World Forum for Harmonization of Vehicle Regulations

Working Party on Passive Safety

Seventieth session

Report of the Working Party on Passive Safety on its seventieth session

"Annex 2C - Example of the arrangement of the approval mark for an accessory

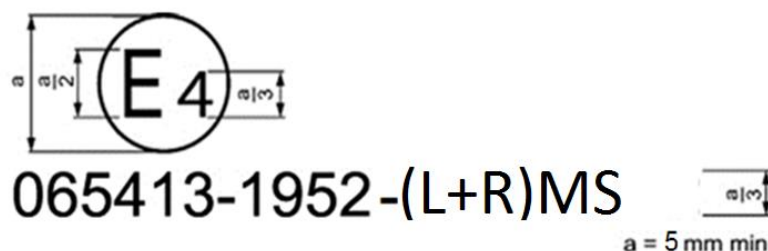
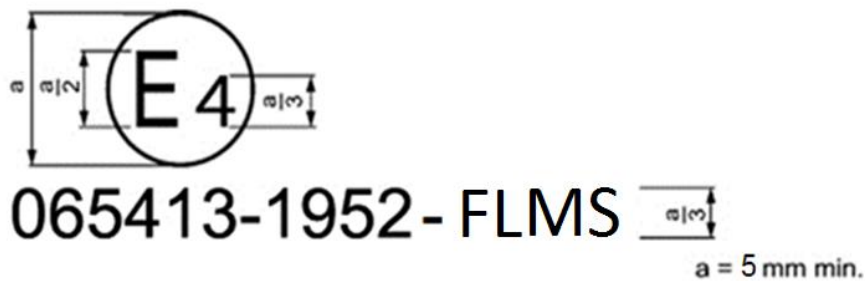
Annex 2C, amend to read:

Example of the arrangement of the approval mark for a universal accessory that will use two helmet locations

The above approval mark affixed to a universal accessory shows that the universal-accessory type concerned has been approved in the Netherlands (E 4) under approval number 065413. The approval number shows that approval was granted in accordance with the requirements of the Regulation incorporating the 06 series

of amendments at the time of approval, that its production batch is 1952 and that is approved for Side and Rear mounting, each mounting position used by one accessory component, and has Microphone and Speakers.

Example of the arrangement of the approval mark for a universal accessory that can use two helmet locations

The above approval mark affixed to a universal accessory shows that the universal accessory type concerned has been approved in the Netherlands (E 4) under approval number 065413. The approval number shows that approval was granted in accordance with the requirements of the Regulation incorporating the 06 series of amendments at the time of approval, that its production batch is 1952 and that is approved for Front or Side mounting and has Microphone and Speakers.

Figure 4
Speakers quasi static crush test corridor

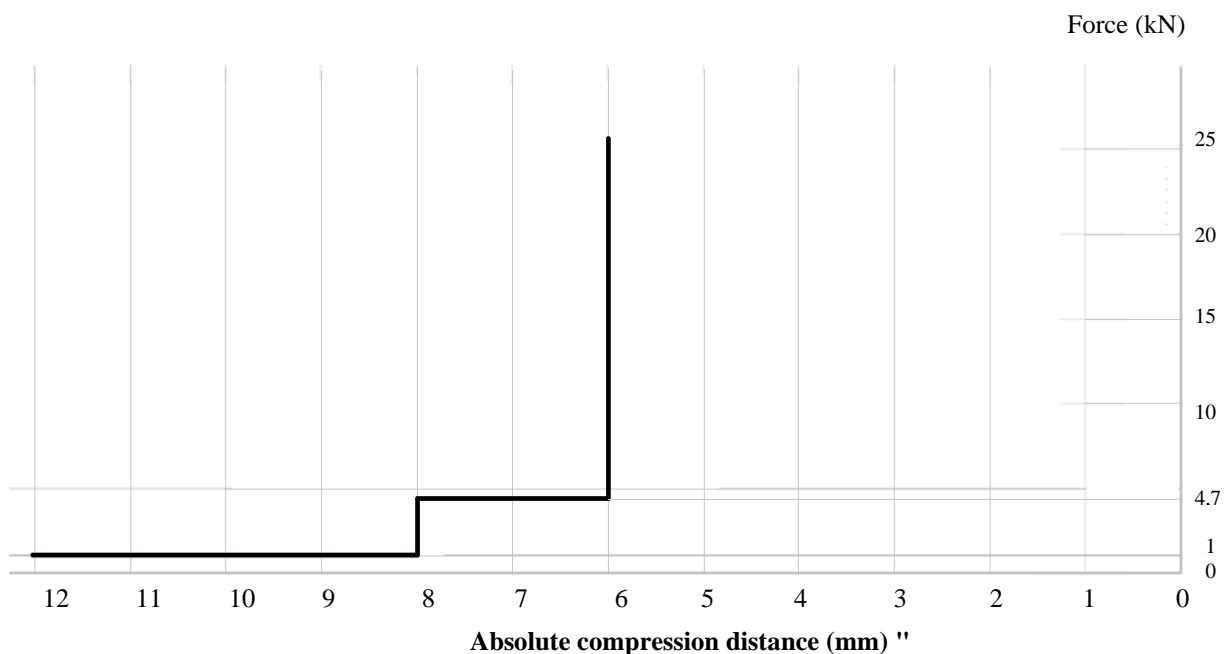
Annex 20, Part 1, paragraphs 1.3. to 1.3.1.1., amend to read:

Start the crush test at a constant speed of 10 mm/min. Record force vs distance at a minimum sampling rate of 10 Hz.

The test ends when the force reaches 10 kN.

The obtained chart for the speakers shall fall below the line defining the upper corridor limit.

Figure 6
Speaker simulator

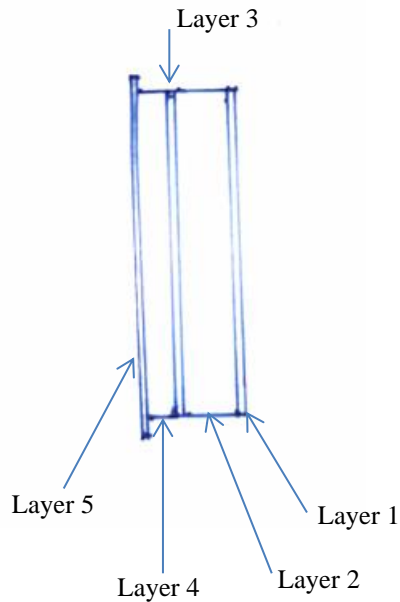
Annex 20, Part 1, paragraphs 1.4.1., amend to read:

"1.4.1. Definition of deformable speaker simulator**1.4.1.1. Component and material specifications**

The speaker simulator is illustrated in Figure 6 of this annex. The dimensions of the individual components of the speaker simulator are listed separately below. The below layers are a possible construction methodology, alternative possibilities are valid provided that they will fulfil the requirements of 1.4.1.3.

Figure 7
Speaker simulator force-deformation corridor

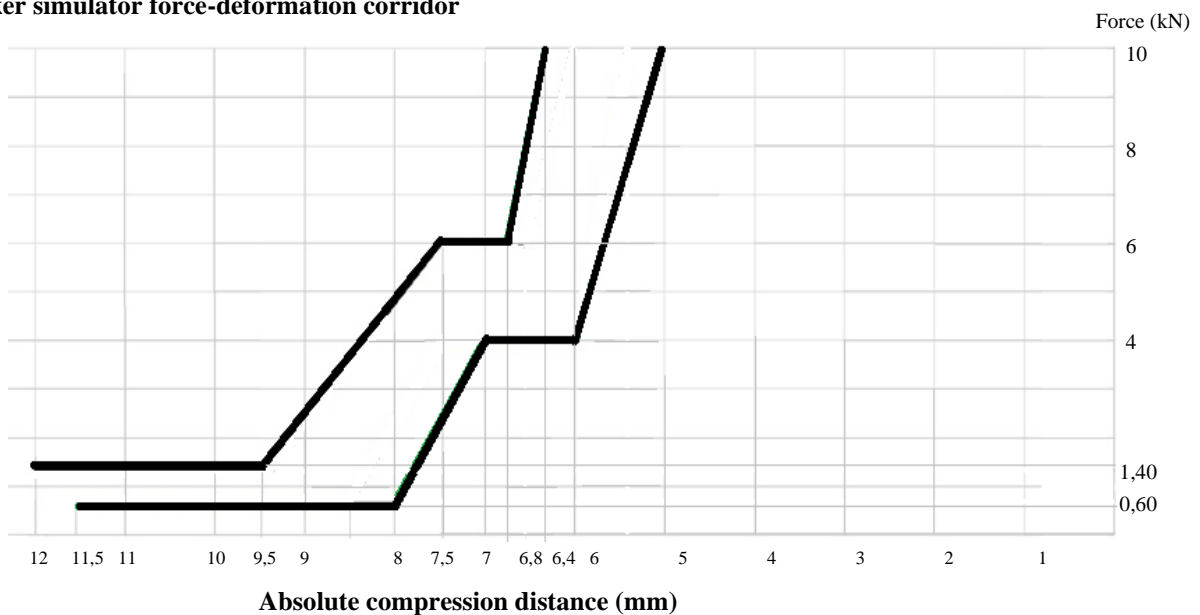
1.4.1.3.1. To ensure the proper behaviour of the speaker simulator, the TS shall ensure that the force-deformation curve will lay within the limits stated in Figure 7.

- 1.4.1.3.2. If the force-deformation curve of the simulator pass over the upper corridor limit or below the lower corridor limit by no more than 0,5 mm, the simulator is considered to pass.

"Figure 8
Free protective padding space for accessories clamping for front and side locations of UA helmets

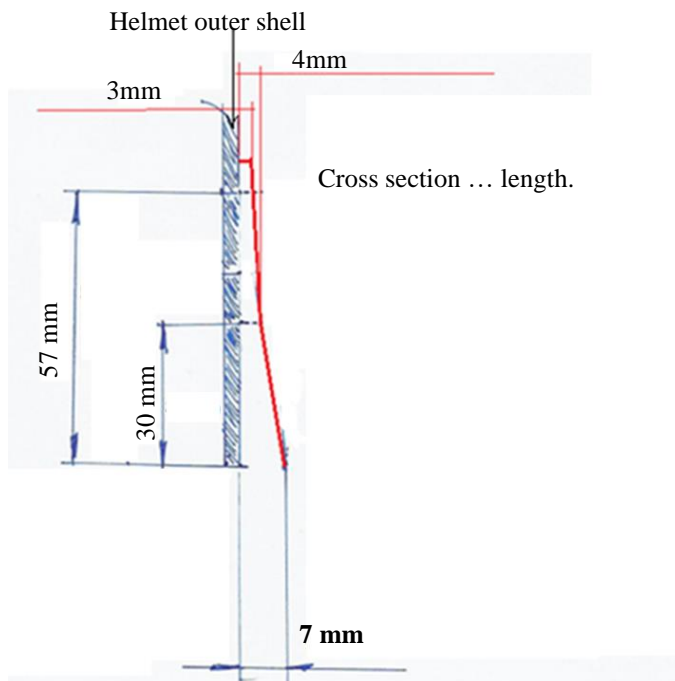
Annex 20, Part 2, paragraph 2.1., Figure 6, amend to read:

"Arrangements of approval marks

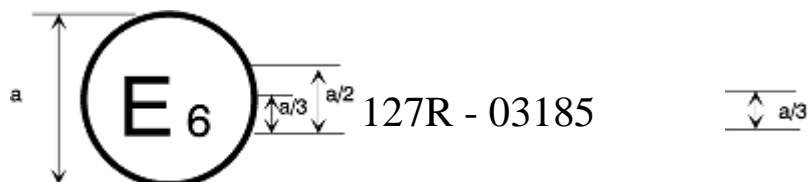
Annex 2, amend to read:

a = 8 mm min

"Figure 5

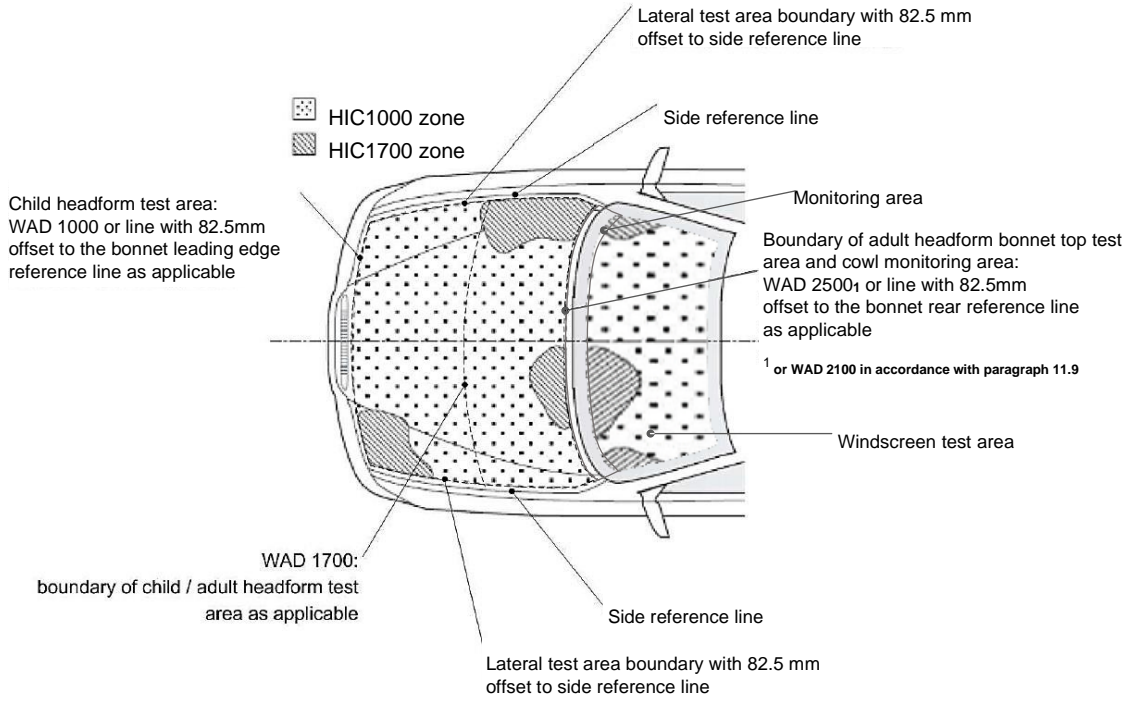
Annex 5, Figure 5., replace by:
